1 ELECTRICAL SITE PLAN

MY PLACE EXTENDED STAY
 3 STORY - 64 GUESTROOM PROTOTYPE
 PROJECT:

SITE PHOTOMETRICS
 PROJECT #
 E100P
 SHEET #

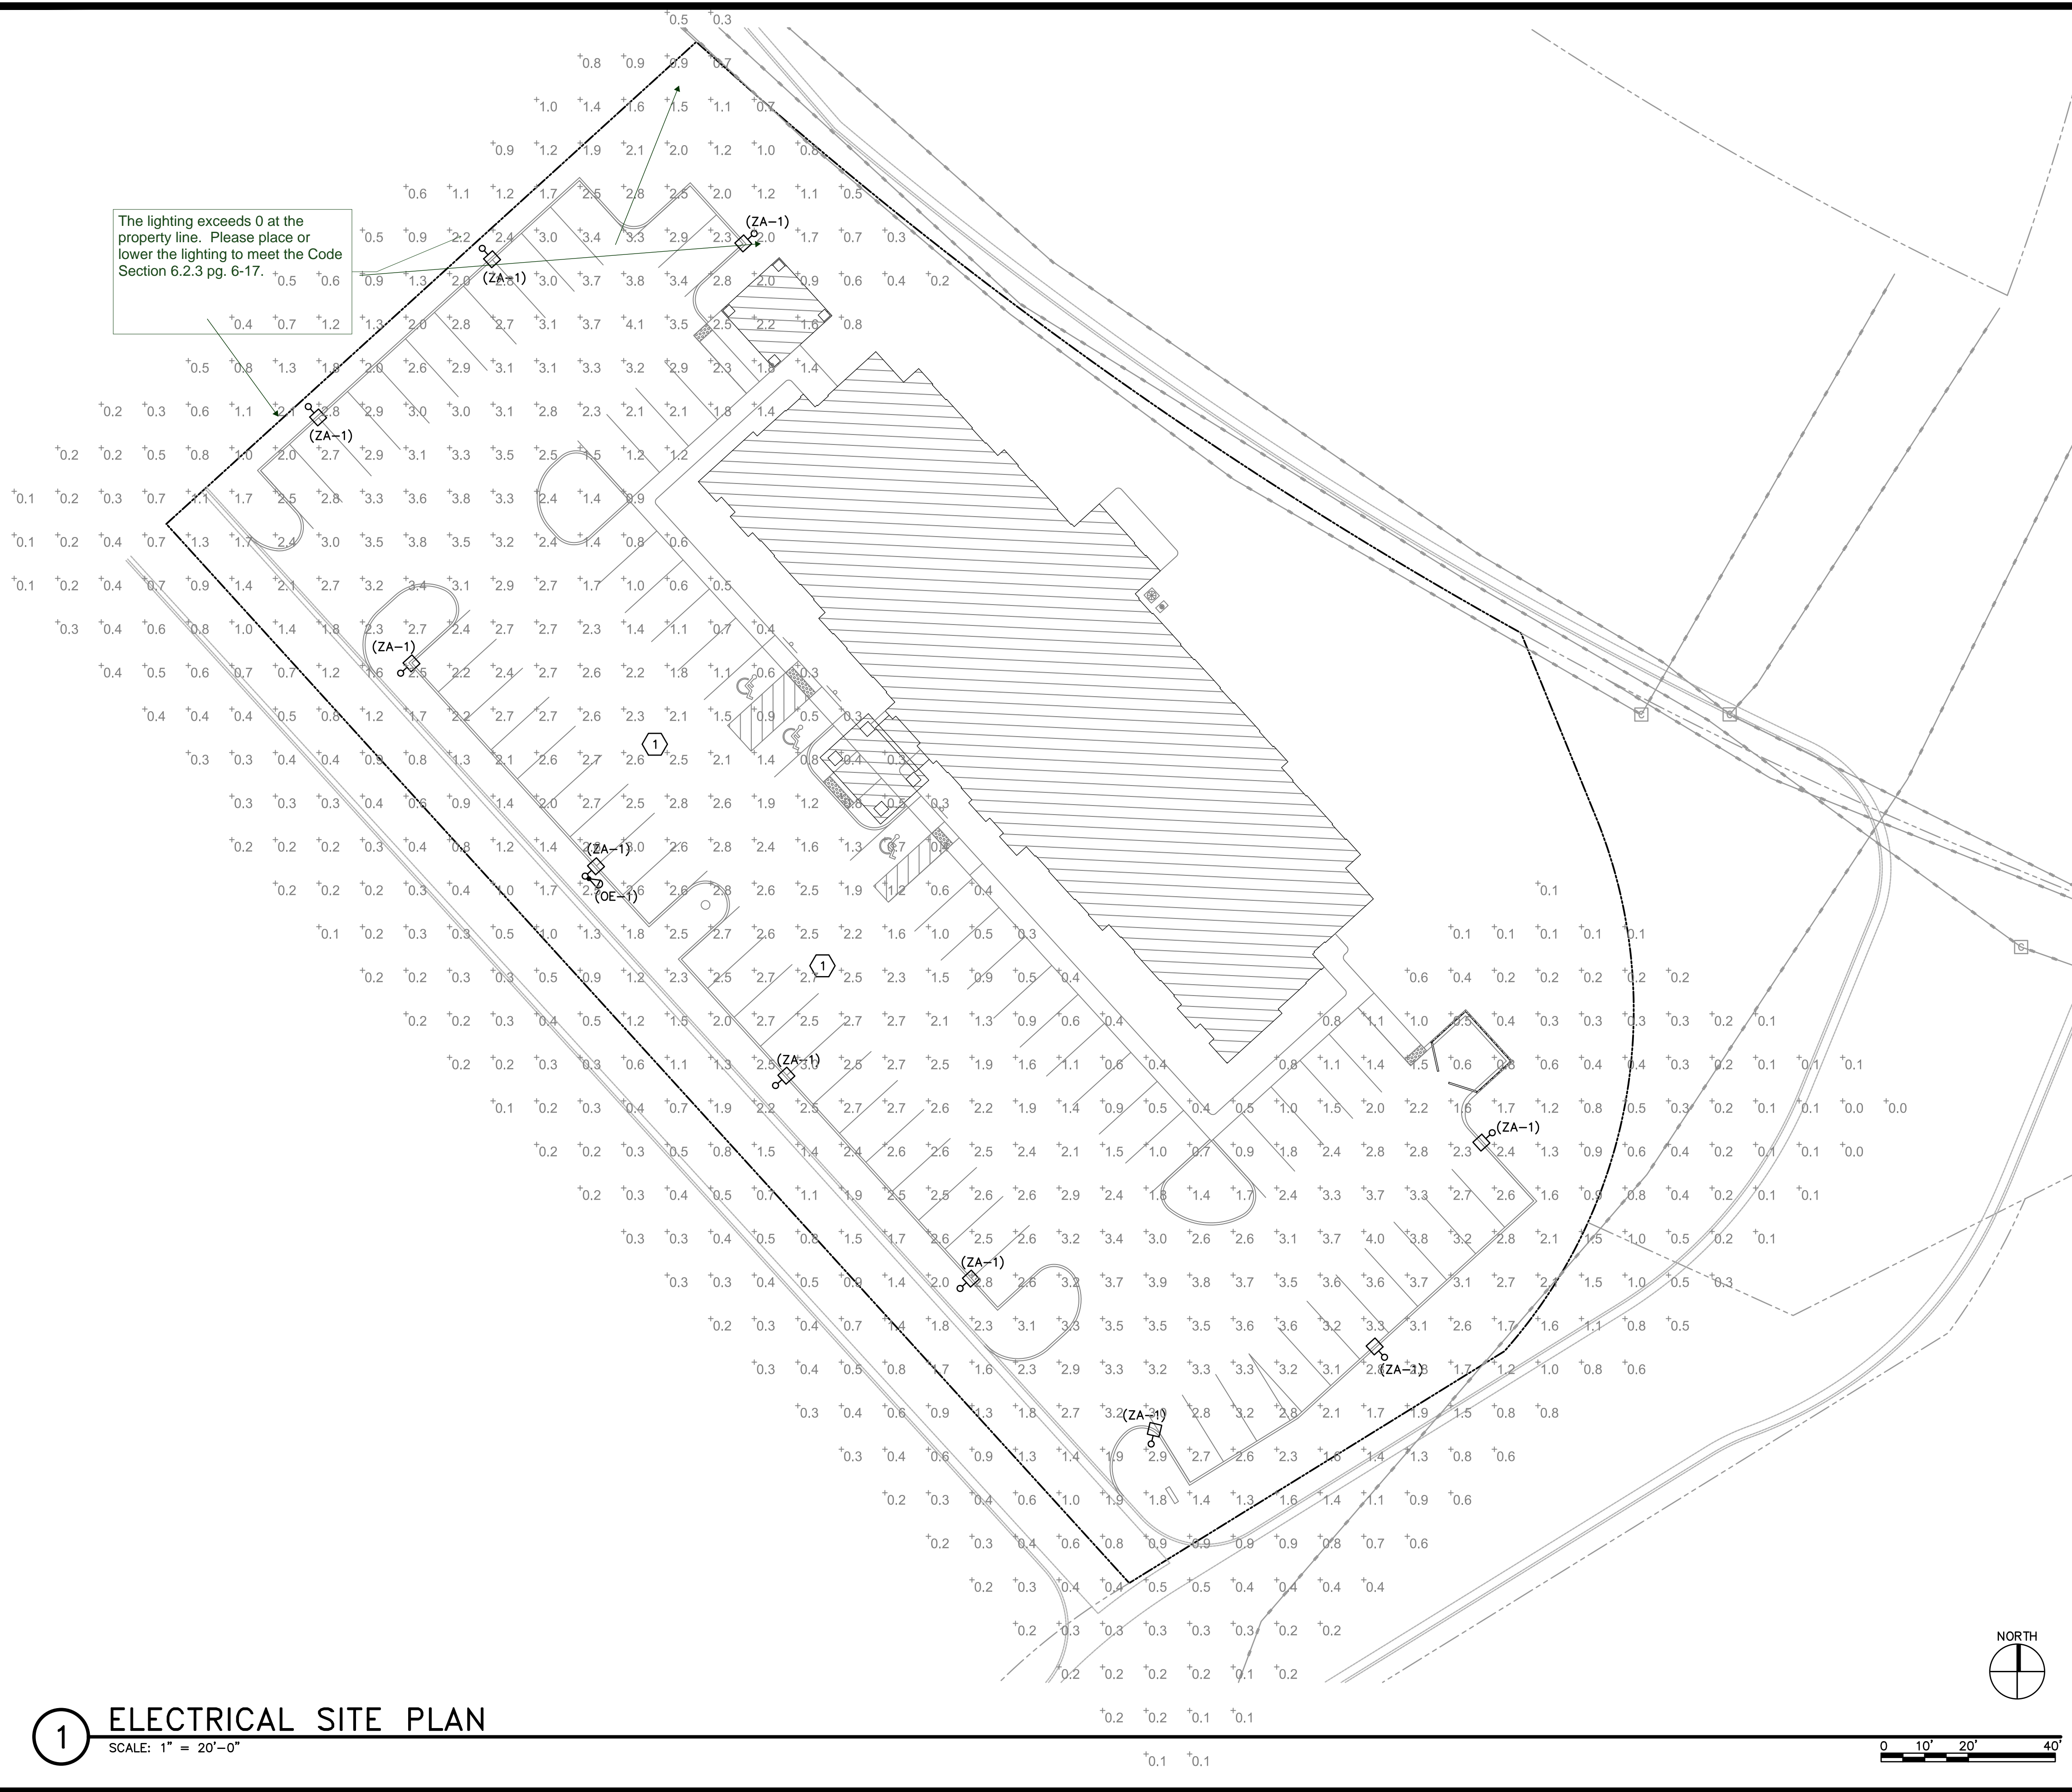
The lighting exceeds 0 at the property line. Please place or lower the lighting to meet the Code Section 6.2.3 pg. 6-17.
